CLEMENTS SUBDIVISION

APPLICATION NUMBER 12 DATE November 20, 2003

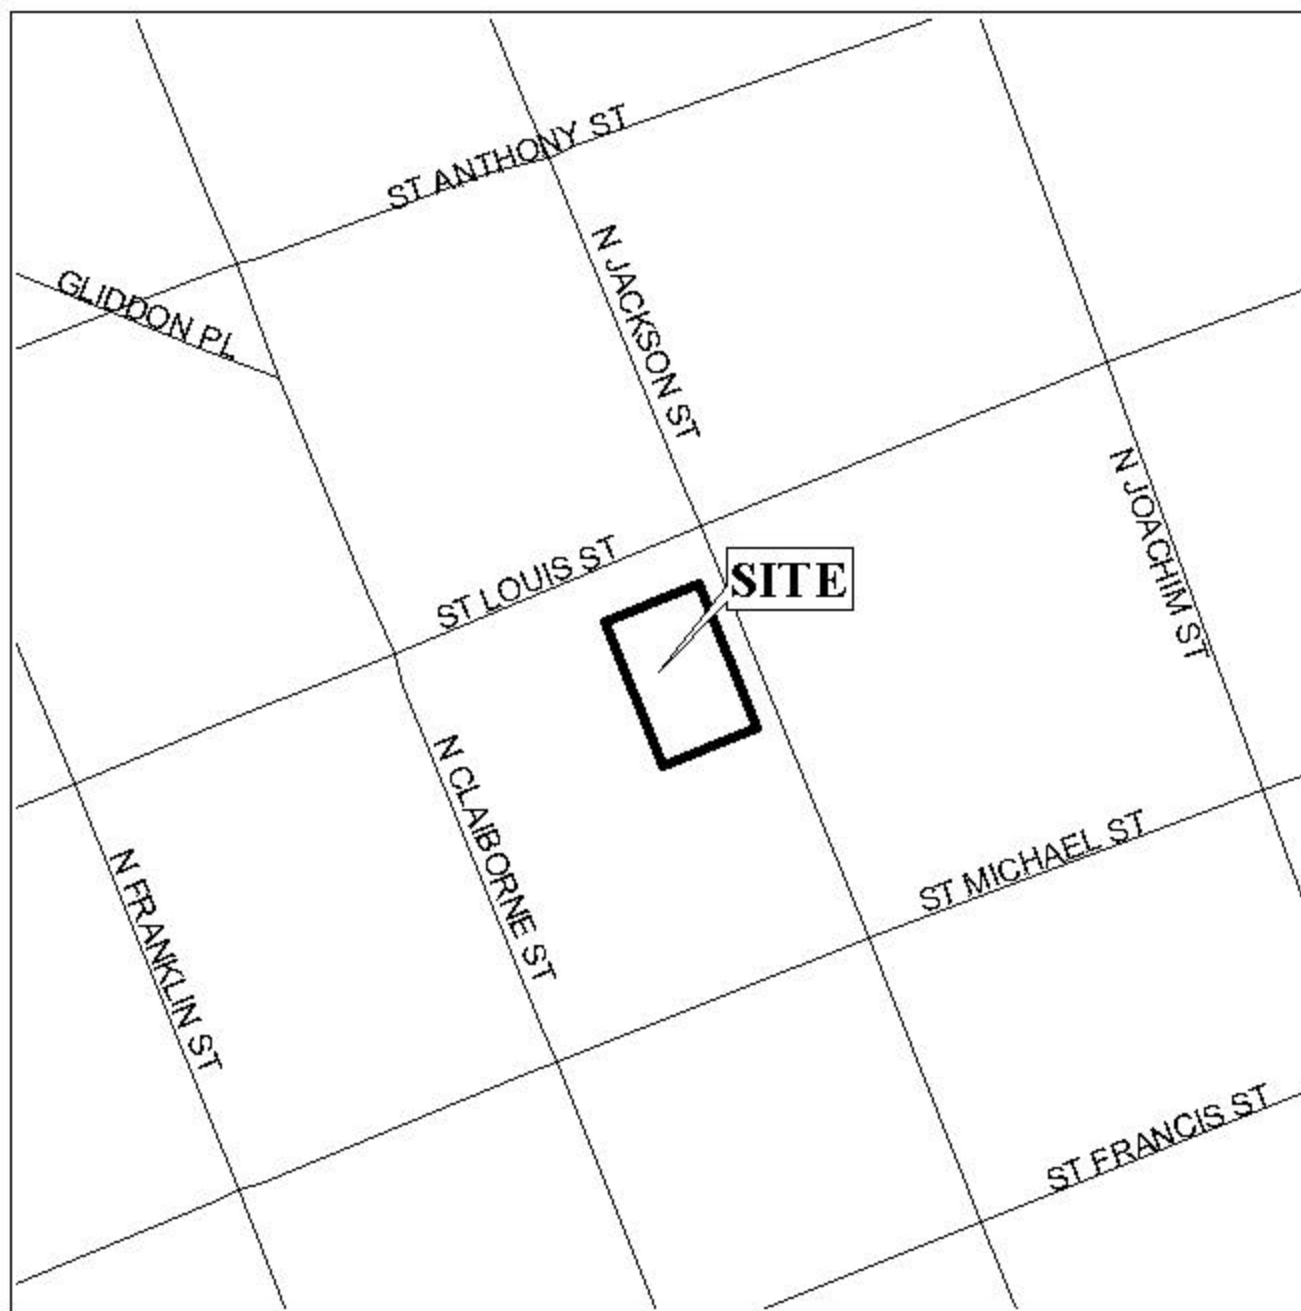
The plat illustrates the proposed 2 lot, 0.2 \pm acre subdivision which is located at the Southwest corner of St. Louis Street and North Jackson Street. The subdivision is served by public water and sanitary sewer.

The purpose of this application is to subdivide a metes and bounds parcel into two lots.

The two lots share access and parking; therefore, the submission and approval of an Administrative Planned Unit Development would be required.

The site is located downtown and many of the small, narrow lots are nonconforming; as proposed, Lot 2 would have 1,667 square feet of area. In B-4 districts, there is no minimum area requirement for building sites; therefore, a waiver of Section V.D.2. would be both required and recommended for the proposed lot. Additionally, Lot 2 would also exceed the width to depth ratio of the Subdivision Regulations, necessitating a waiver of Section V.D.2.

With a waiver of Sections V.D.2. and V.D.3., the plat meets the minimum requirements of the Subdivision Regulations and is recommended for Tentative Approval subject to the following condition: 1) the submission of an Administrative PUD for the shared access and parking.
